To: Township Board

RE: Preliminary site plan application 22-003 9704 Kress Road

To: Planning Commissioners
From: Amy Steffens, AICP
Planning and Zoning Director
Date: March 15, 2023
Agenda Item: 7a
Project address and Description: **Preliminary Site Plan Review (SPA 22-0006)** for a second-story addition over an existing commercial building to accommodate two residential units. Project will include exterior renovations to commercial building, removal of asphalt parking areas to north and west, and installation of new parking lot to the south. Applicant has requested waivers to the landscaping and parking requirements.
Owner: D&G Real Estate
Applicant: David Woolley
Agent: Momus Inc.

9704 KRESS ROAD
 Preliminary Site Plan

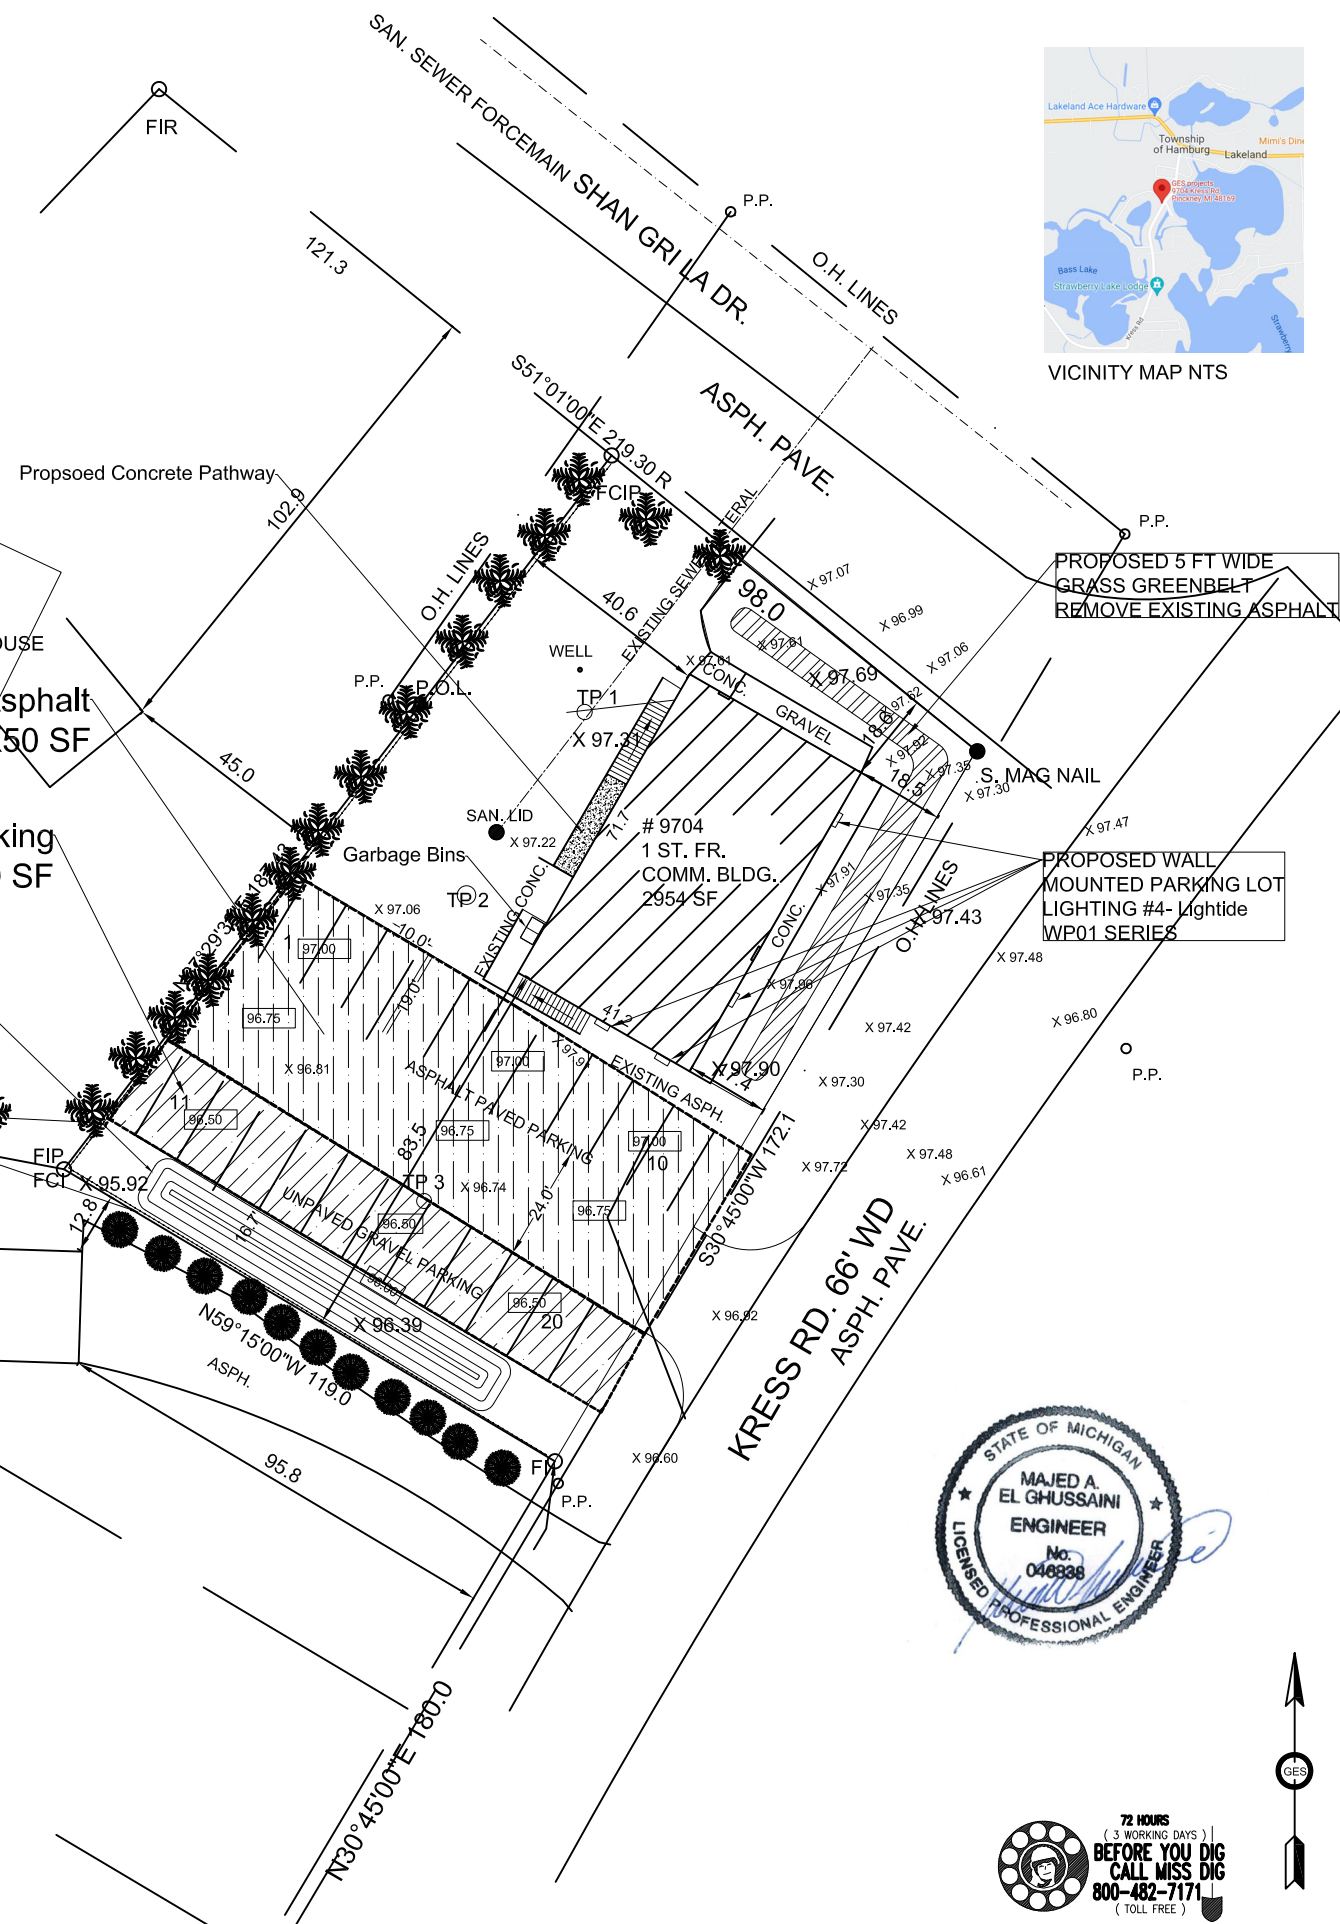
The Planning Commission should consider requiring the applicant, at a minimum, to add a 6-foot-tall solid fence near the south side of the parking lot to lessen the impact from this project on the property to the south, with the required shrubs on the outside of the fence to soften the aesthetic appearance of the fence.

The Planning Commission should consider requiring the applicant, at a minimum, to add a 6-foot-tall solid fence along the west property boundary to lessen the impact from this project on the property to the west, and to install the required landscaping material on the west side of the fence. Trees and shrubs should be installed in the existing grassed yard.

Staff comment: A six-foot tall wooden fence is proposed along the west and south property boundary. However, no additional landscaping is provided.

Staff comment: While a six-foot tall wooden fence is proposed along the west property boundary, no additional landscaping is proposed along the fence nor in the west rear yard.

Staff comment: No landscaping is proposed in the east front yard or the north front yard.

Staff comment: No landscaping is proposed along the bioswale.

Staff comment: a six-foot tall fence is proposed per the revised plans along the south property boundary.

Staff comment: a six-foot tall fence is proposed per the revised plans along the west property boundary.

DESIGNED MG	12.10.21										
DRAWN MG	12.10.21										
CHECKED MG											
1:30											
9704 KRESS ROAD Preliminary Landscaping Plan											
HAMBURG TWP, LIVINGSTON COUNTY 15-21-405-016											
GES-LLC Consulting Engineers Info@GSMICH.COM 734-272-9763

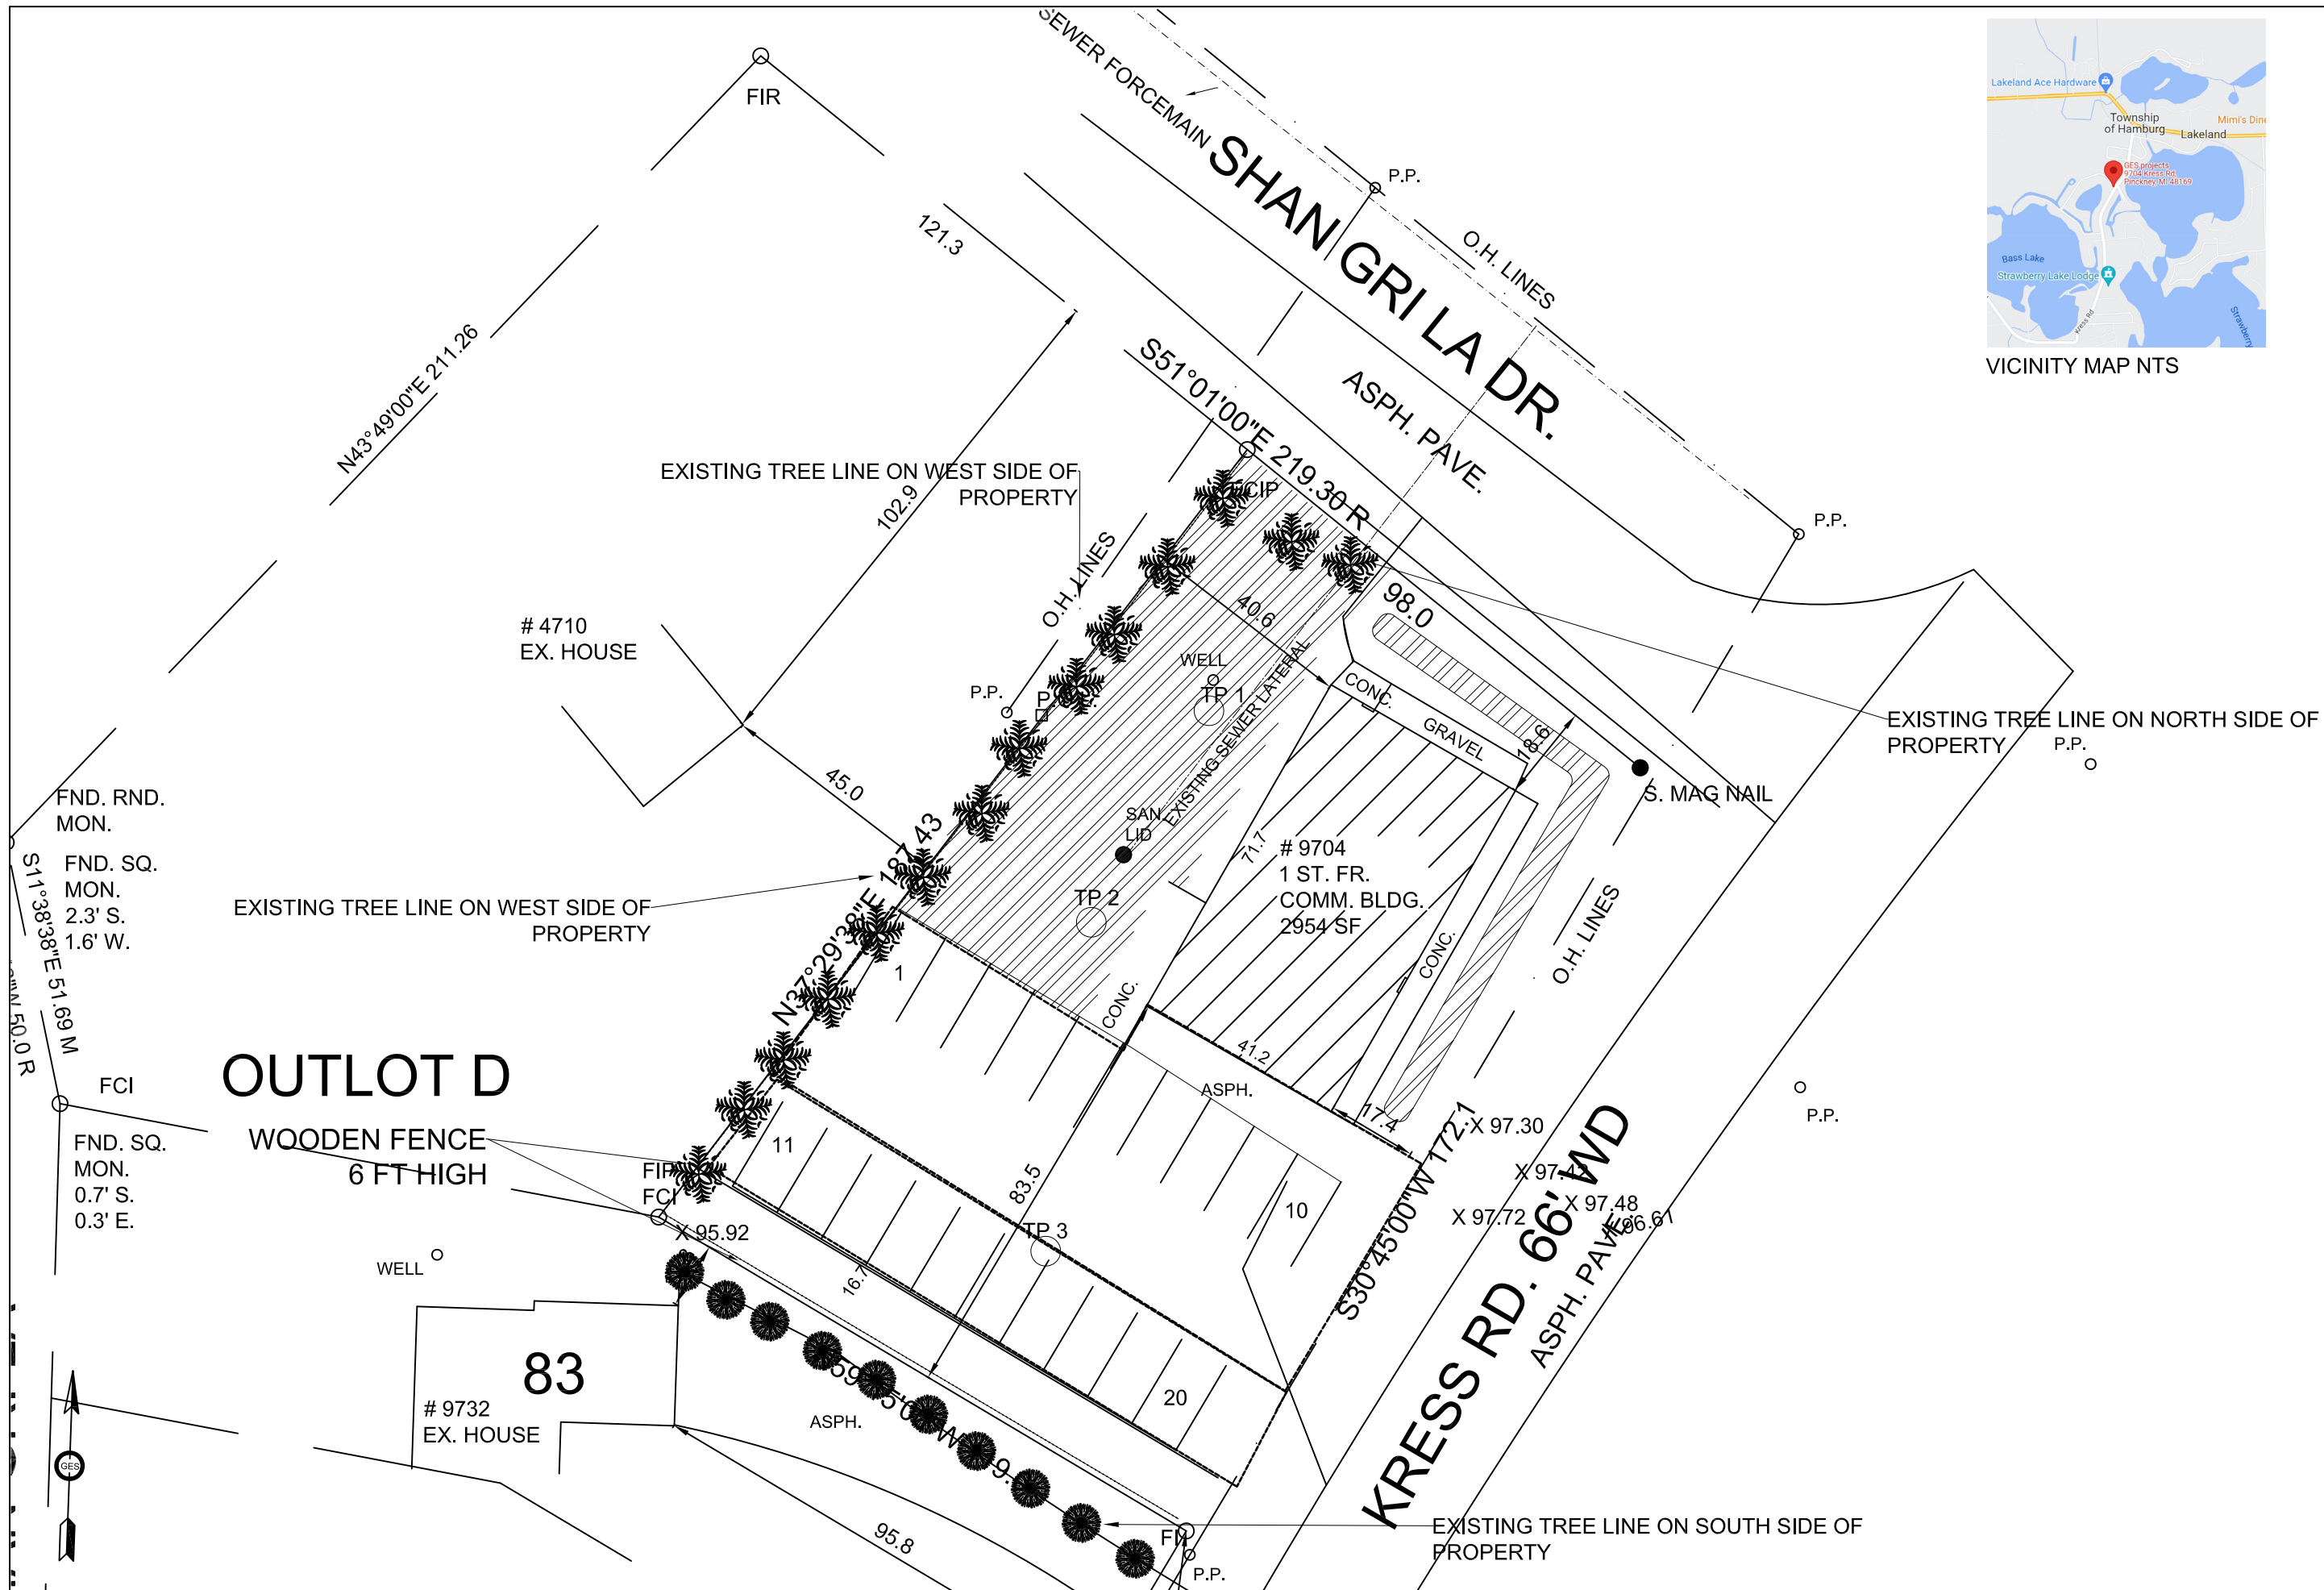
- J. Landscaping, including trees, shrubs and other vegetative material is provided to maintain, improve and/or restore the aesthetic quality of the site.**
As proposed, the landscaping plan is deficient to improve the aesthetic quality of the site, particularly with the adjacent residential use and the proposed residential use. With the suggested landscaping conditions this requirement would be met.
